**SITE PLAN REVIEW SHEET  
ENVIRONMENTAL VARIANCE REQUEST ONLY**

**CASE:** SP-2020-0228D

**PROJECT NAME:** Brushy Creek Regional Utility Authority Raw Water Pump Station

## **ENVIRONMENTAL COMMISSION MOTION 20201202 002a**

OVERALL EXISTING CONDITIONS

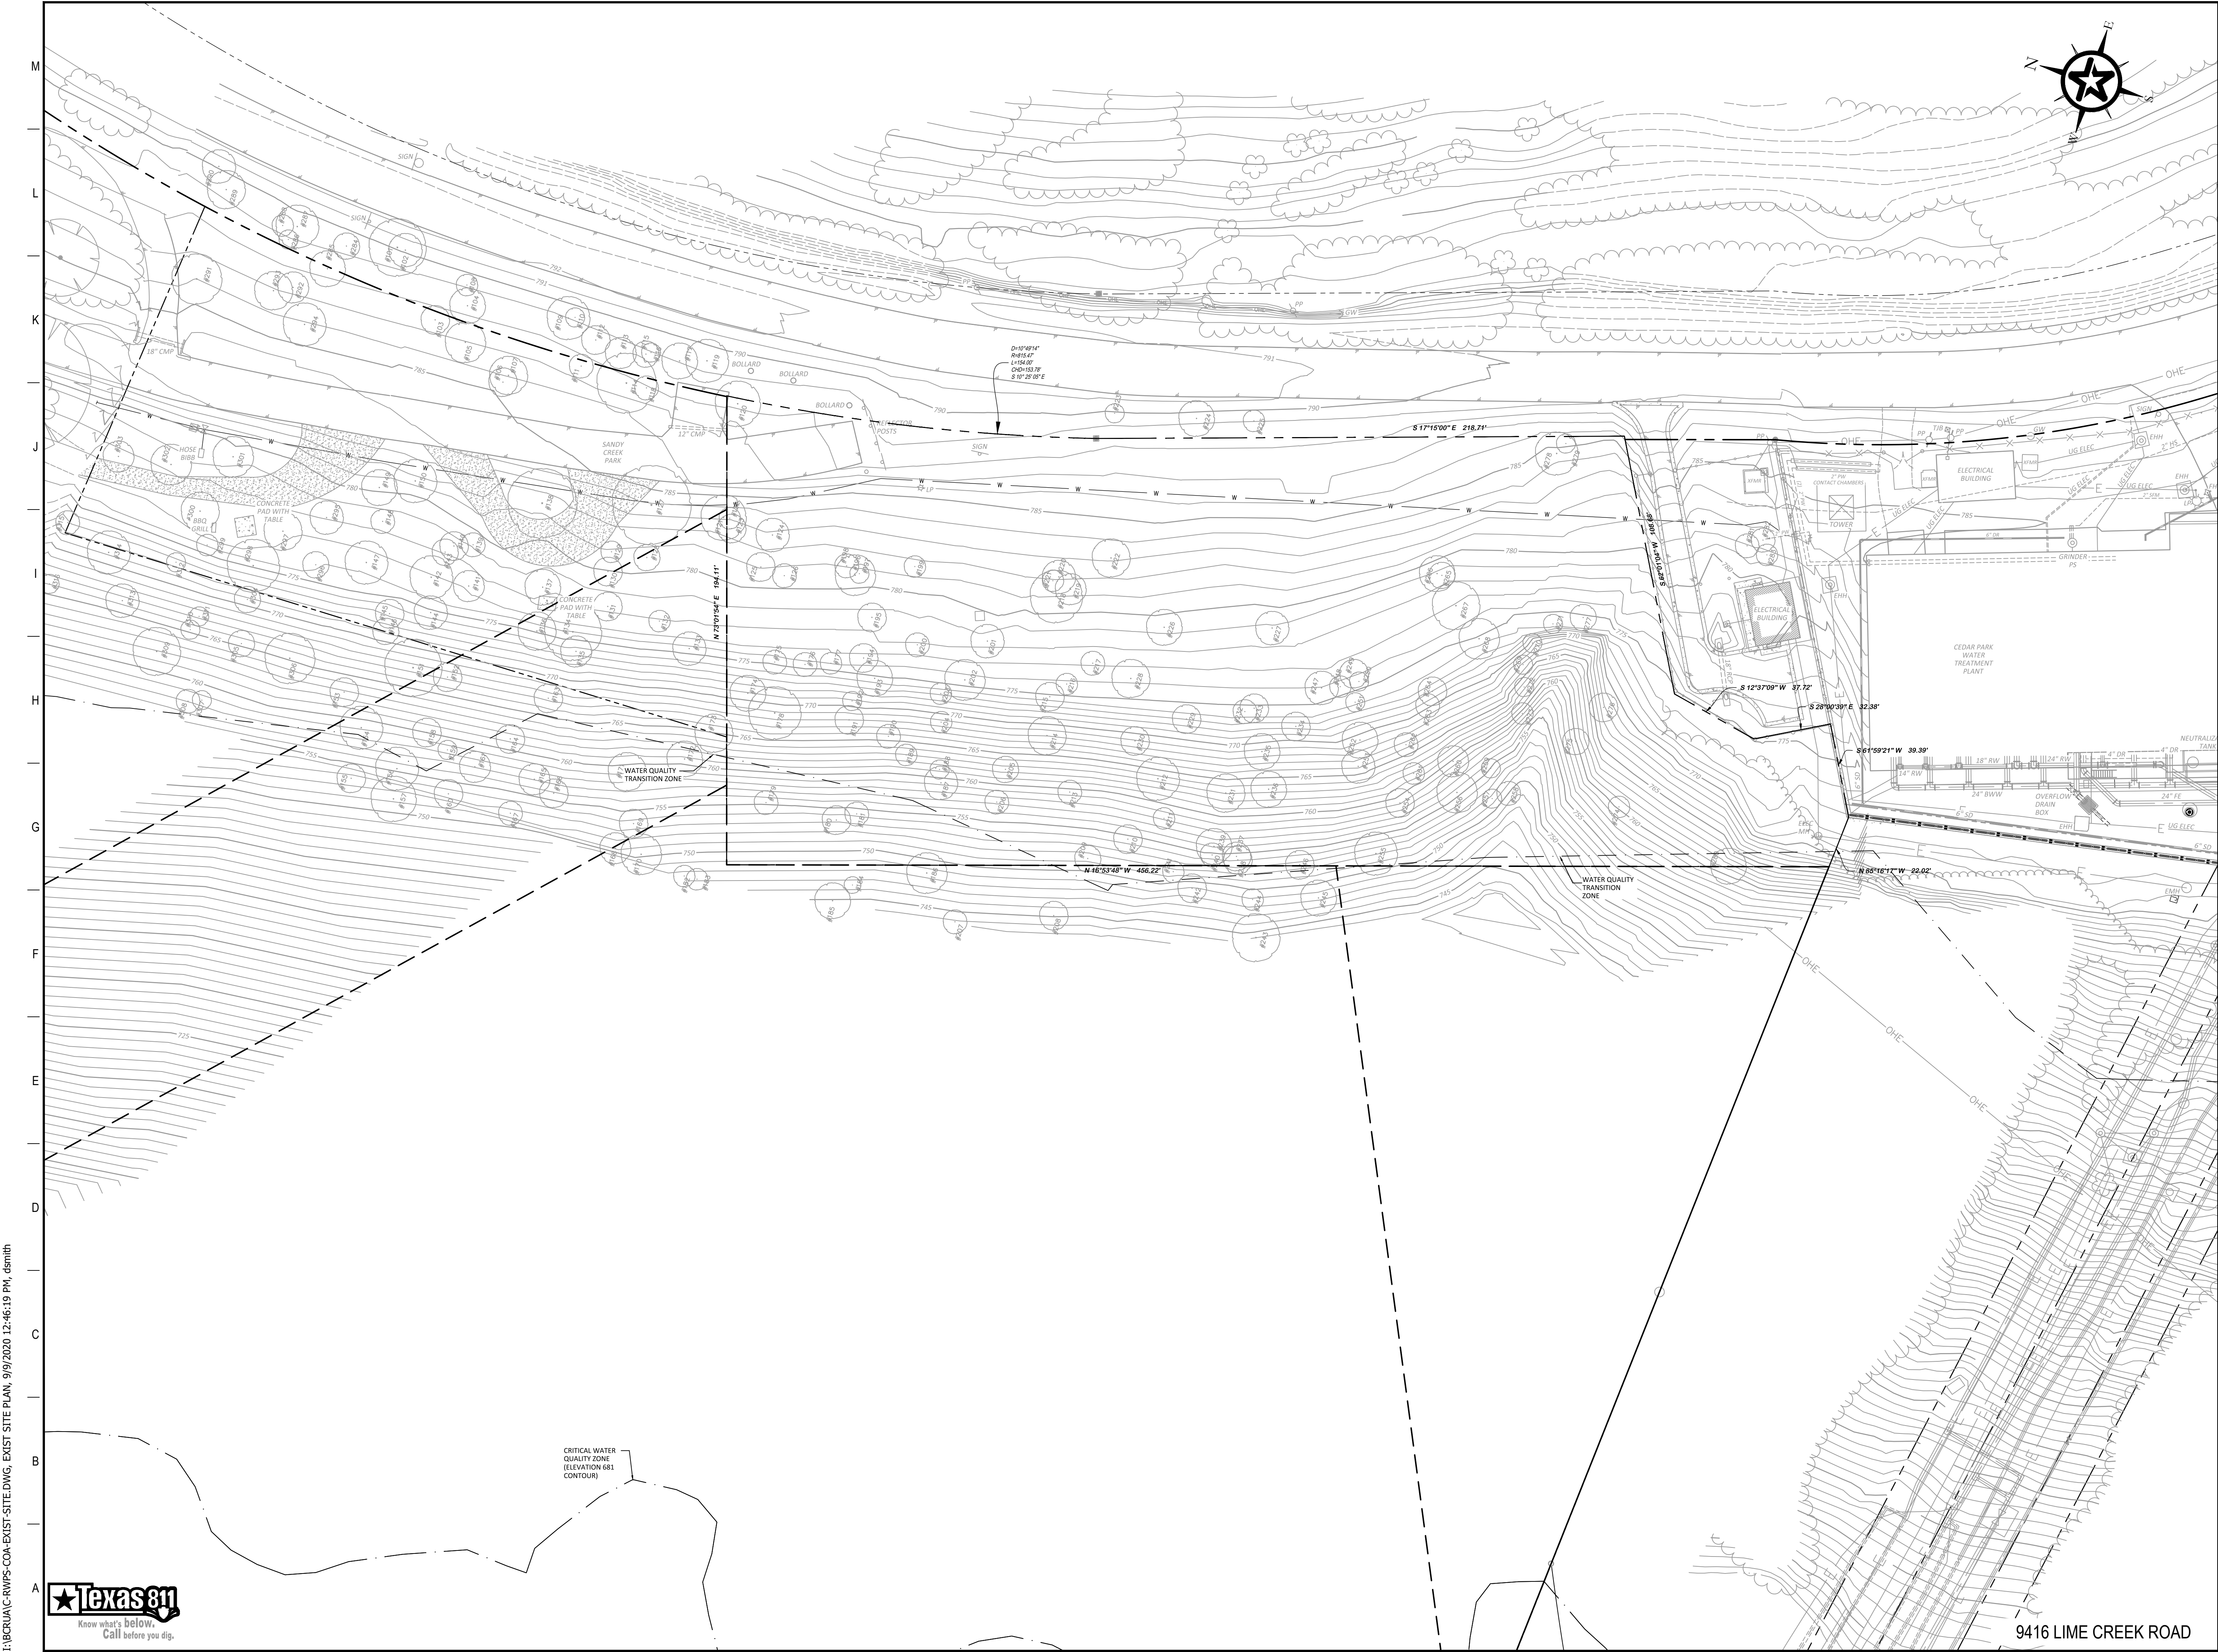
Yes. All the proposed construction on the site requiring the variances is necessitated by the scale of the property and the site constraints of the existing topography (see Overall Existing Conditions exhibit, page 33). The relative small area of the site is due to the parceling of the site by LCRA, and is the only property along Lake Travis that was conveyed to BCRUA for this facility.

DIMENSIONED SITE PLAN

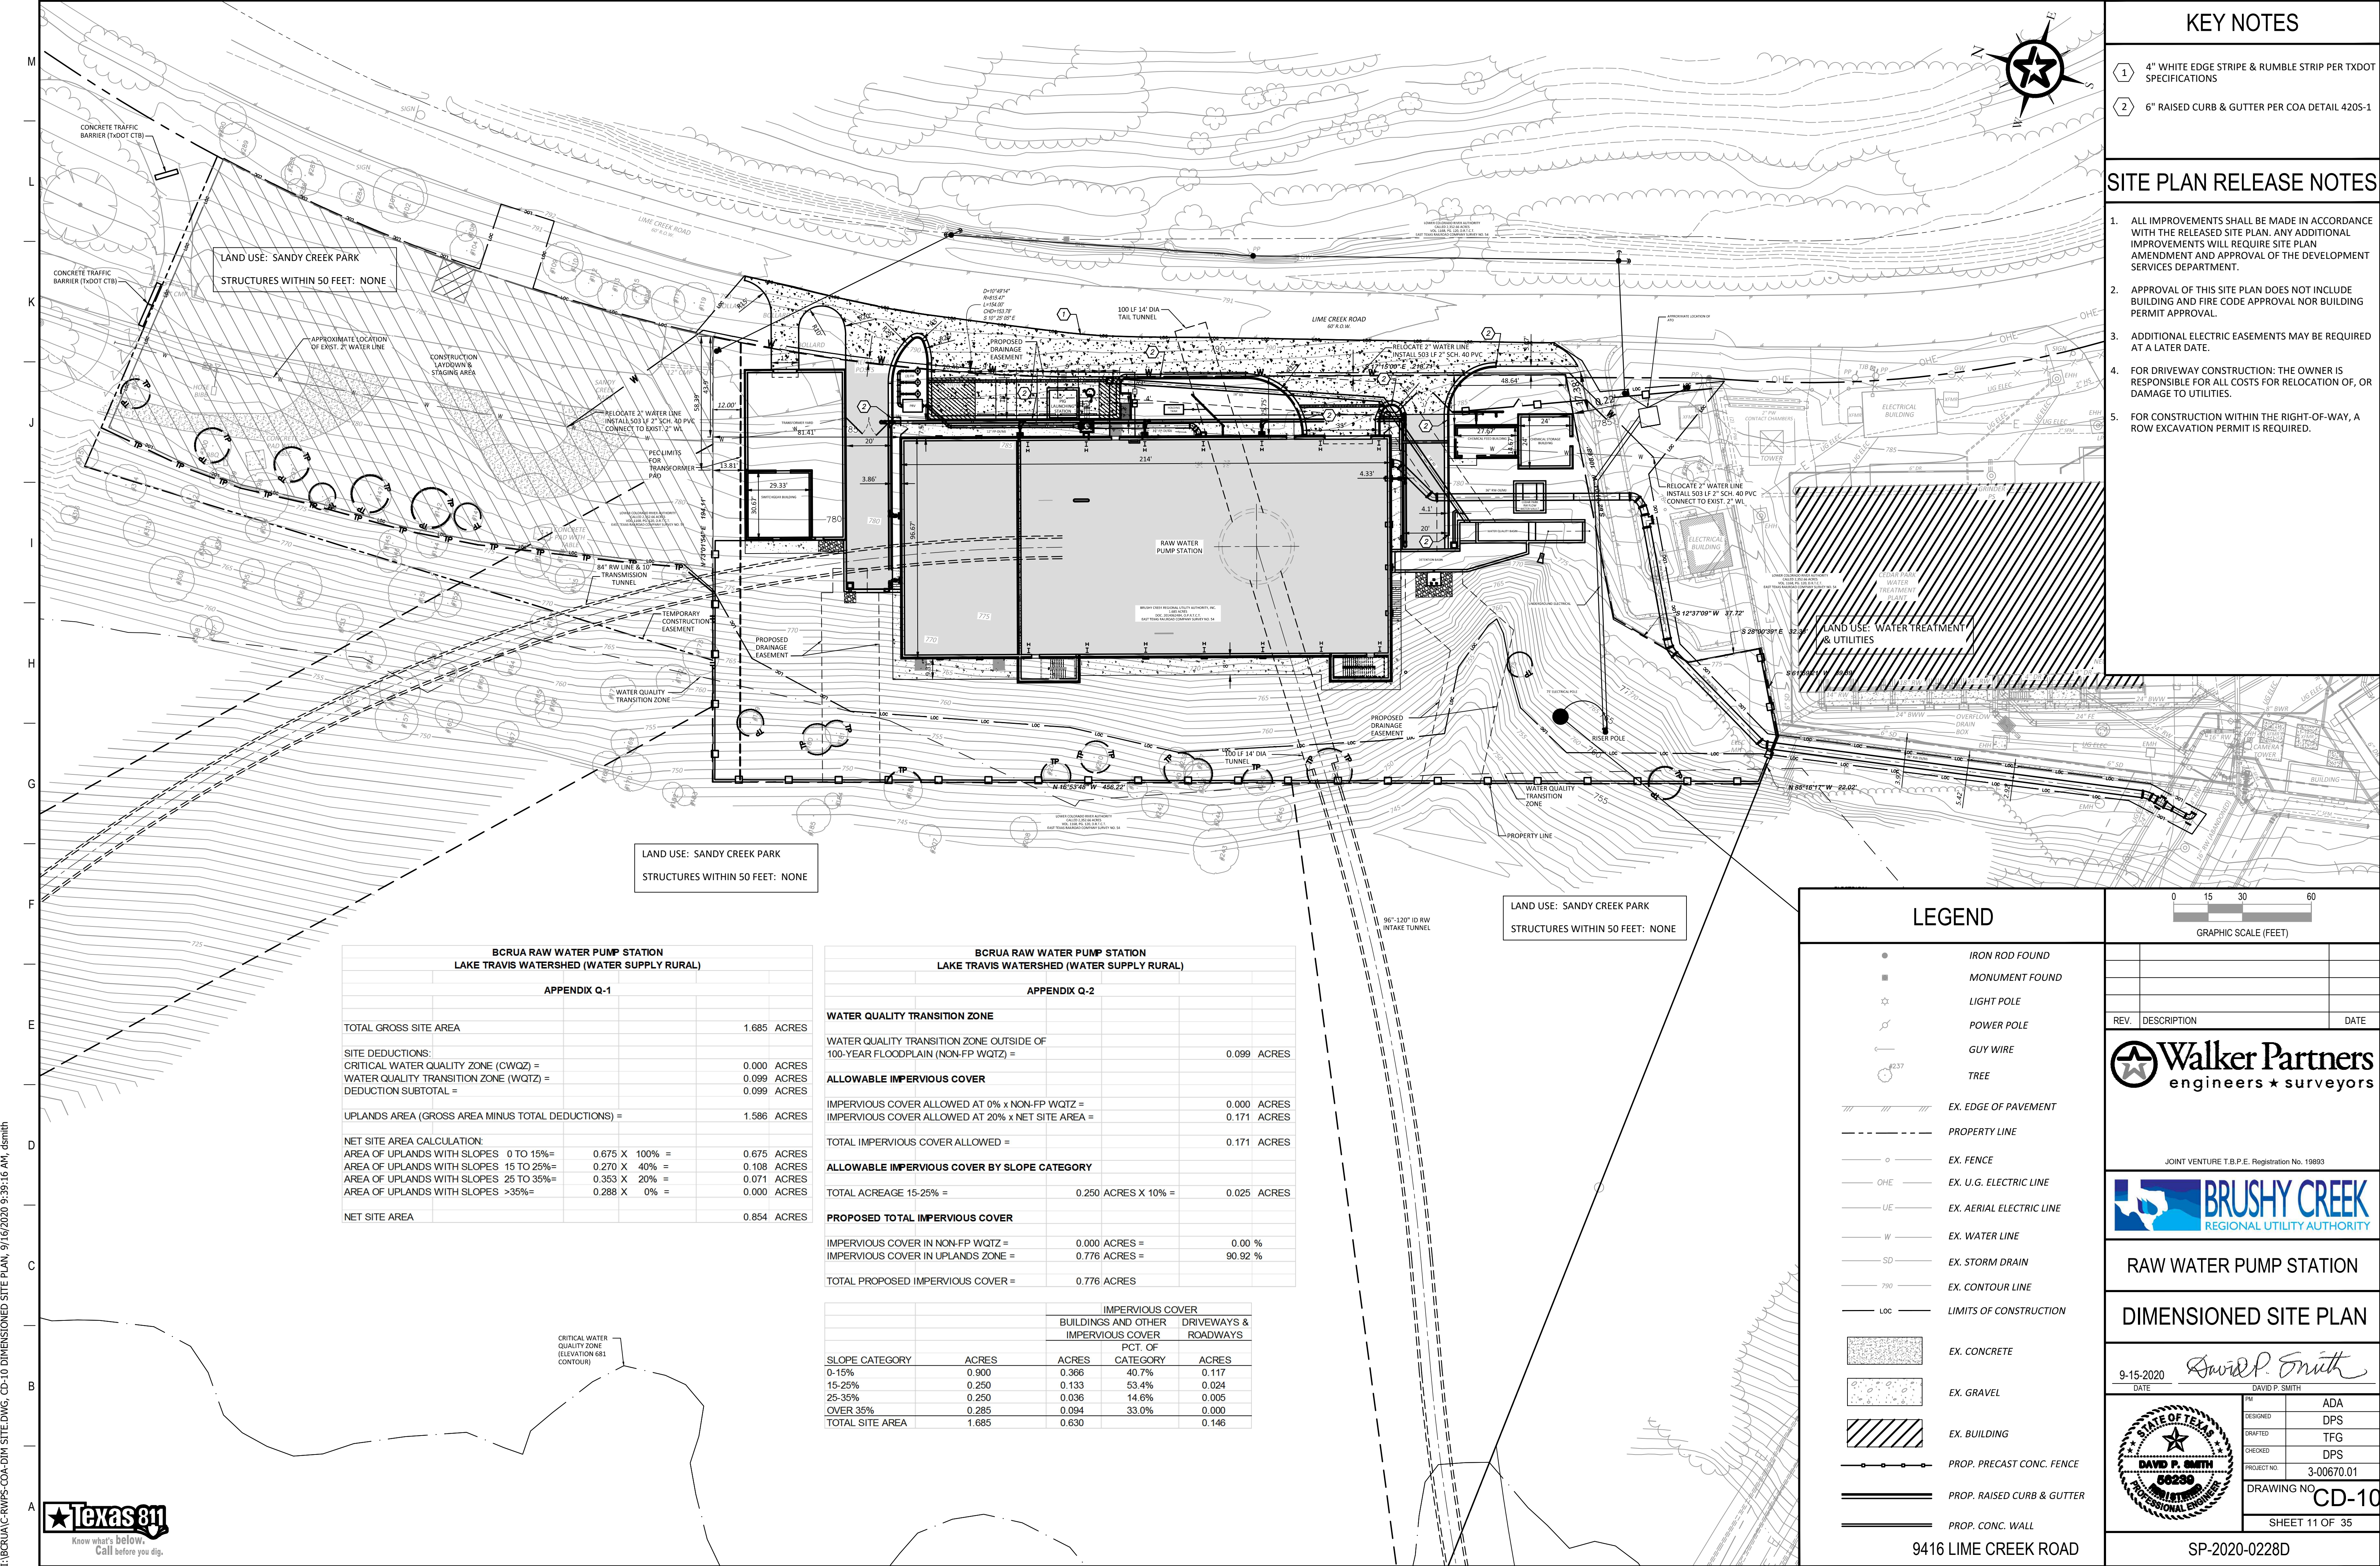
Despite the topographic challenges of the property, the site plan provides for greater overall environmental protection by reducing the amount of parking spaces, drive/fire lanes, and fill to construct these features to only the minimum required for the functioning of the facility or that allowed by Travis County fire regulations (see Dimensioned Site Plan exhibit, page 34).

### FILL EXHIBIT

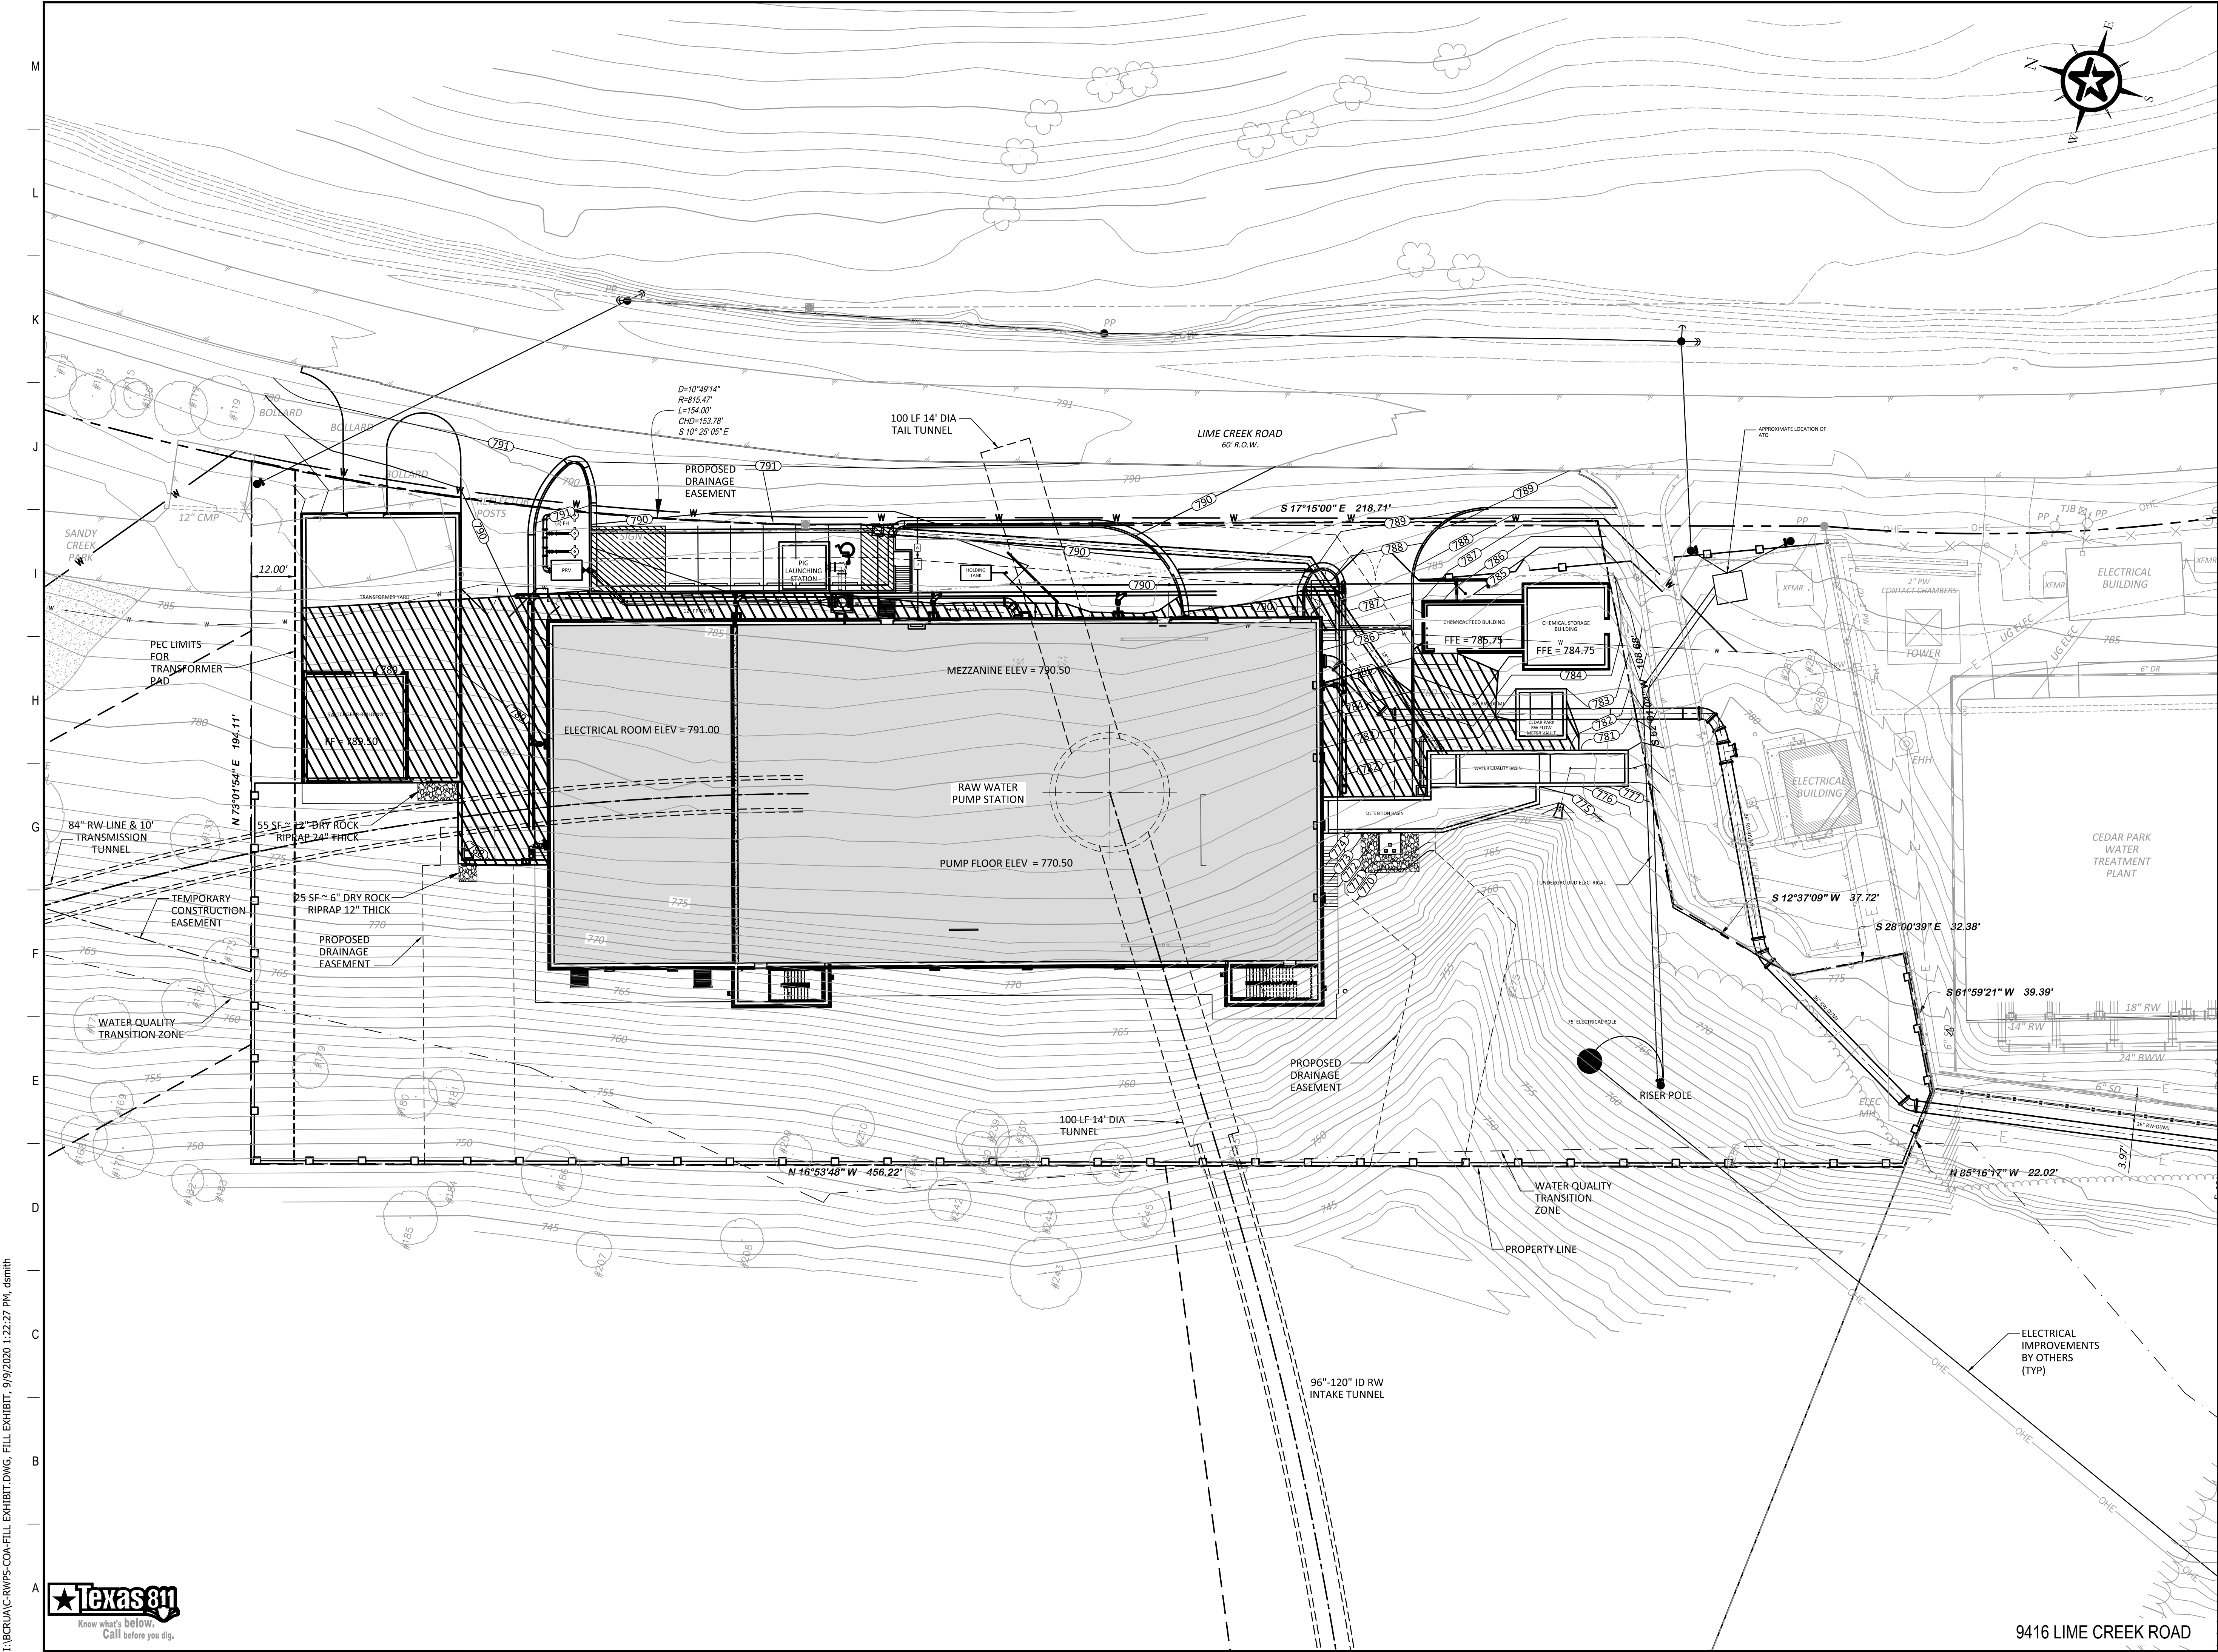
The surface parking and drive/fire lanes are the only site features that require the excess fill material, to the extent as needed to satisfy the

maximum allowed gradient set by Travis County fire regulations (see Fill Exhibit, page 35). The surface parking lot and the building are sited on the least sloped areas of the site, and only propose the amount of square footage necessary for the functioning of the facility to meet the projected water demands and provide safe accommodations for the employees (see Slope Exhibit, page 36).
